NEW FEATURES

1. Front Design

The front design of the Australia, G.C.C. countries, Taiwan, and Hong Kong models has been changed. The changed items are as follows:

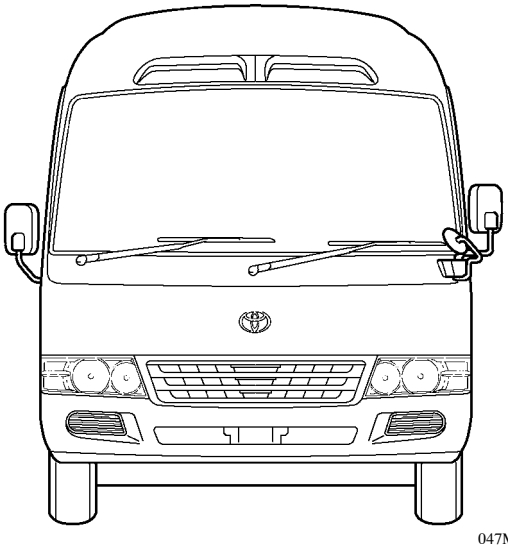
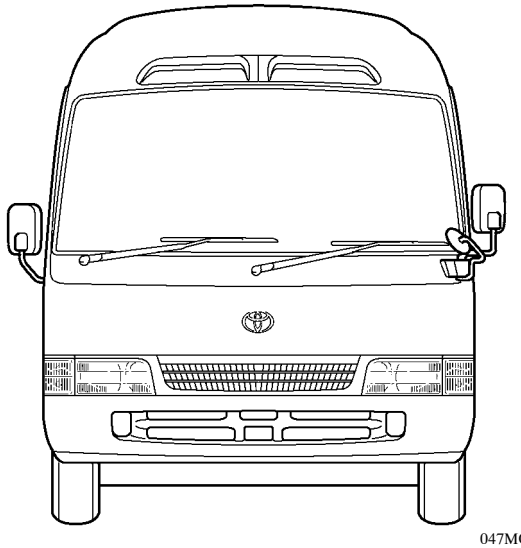
- The headlight, front bumper, and radiator grille have been changed to have the design featuring wideness and low center-of-gravity under the theme of V-shape.

▶ Headlight ◀

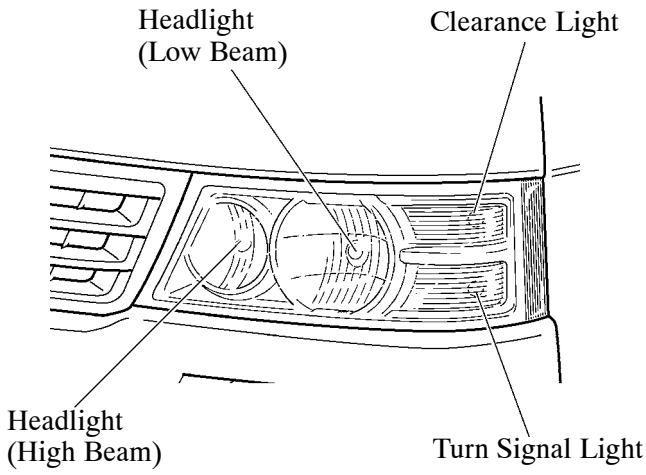
- A 4-beam halogen headlight which integrates a high beam, a low beam, a clearance light, and a front turn signal light is provided as standard equipment.

▶ Radiator Grille ◀

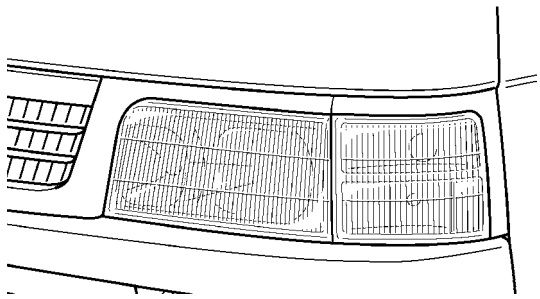
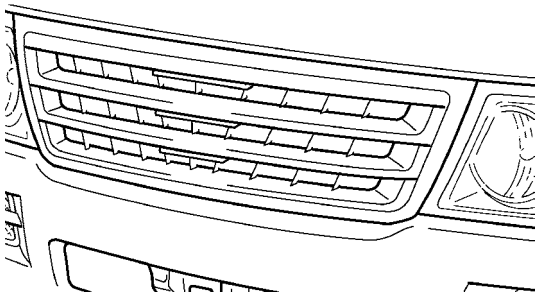
- A radiator grille of a material color is provided for all models. A radiator grille of an exterior color is provided for the models with the beige metallic exterior.

▶ Front Fog Light Bezel and Fog Light Cover ◀

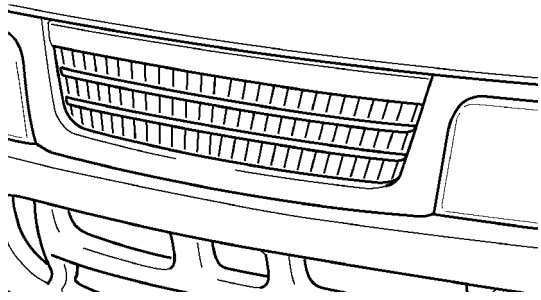
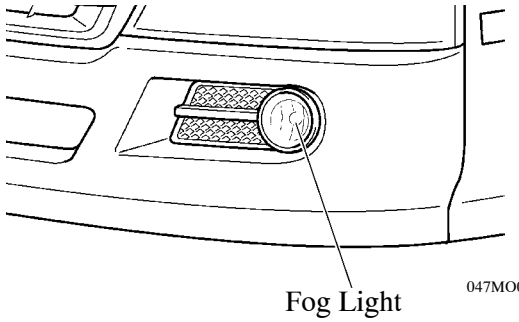
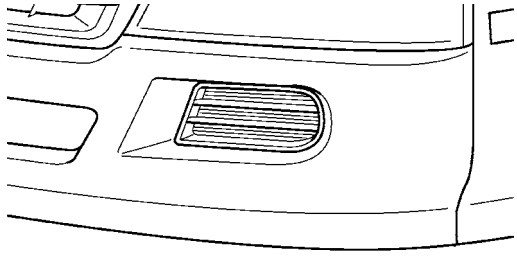
- The design of the front fog light and front fog light bezel has been changed. Fog light covers are provided for the models without the front fog lights. Fog light bezels of an exterior color are provided for the models with the beige metallic exterior.

▶ Side Turn Signal Light ◀

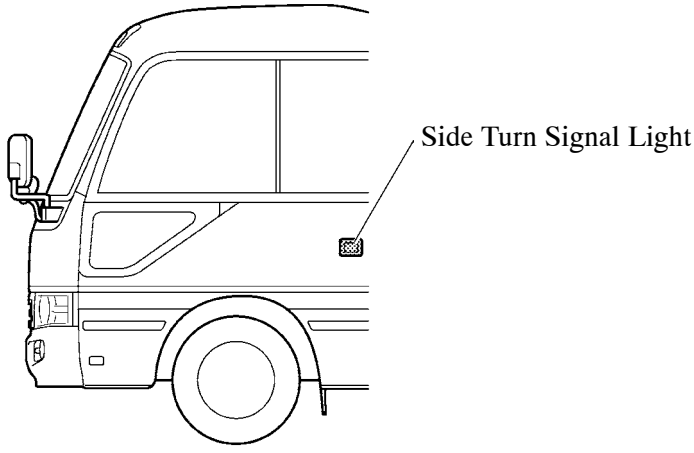
- Along with the changes in the front design, the position of the side turn signal light has been changed to the side panel for the Australia, G.C.C. countries, and Hong Kong models.
